MIL "ON" DTC P2646 and/or P265B

Service Category Engine/Hybrid System

Section Engine Control

YEAR(S)	MODEL(S)	ADDITIONAL INFORMATION
2014	Corolla	VDS(s): BPRHE

Figure 1. Location of Authorized Modifications Label on 2014 Corolla

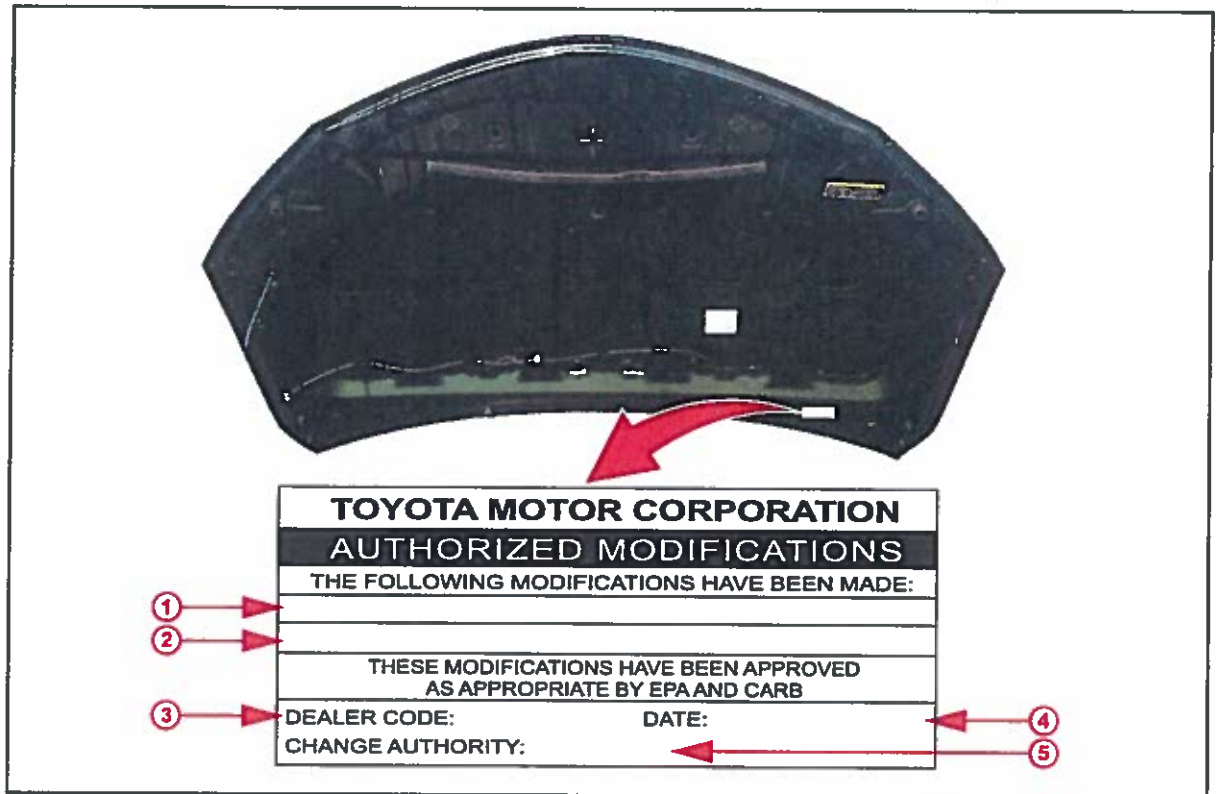
1. Using Techstream, check for stored DTCs. If DTC P2646 and/or P265B is present, proceed to step 2. If these DTCs are not present, this bulletin does NOT apply. Continue diagnosis per Repair Manual procedures.
2. Check for the Authorized Modifications Label affixed to the vehicle in the location shown in Figure 1. Confirm if the ECM (PCM) calibration has been updated. If the calibration ID listed is NOT the latest ECM (PCM) calibration — go to step 3.

B. Affix the Authorized Modifications Label to the vehicle at the location shown in Figure 1. The Authorized Modifications Label is available through the MDC, P/N 00451-00001-LBL.

1	Replacement ECM (PCM) Part Number (i.e., 89661-0ZD31)
2	New Calibration ID(s) (i.e., 302Y6100)
3	Dealer Code

4	Date Completed
5	This SB Number
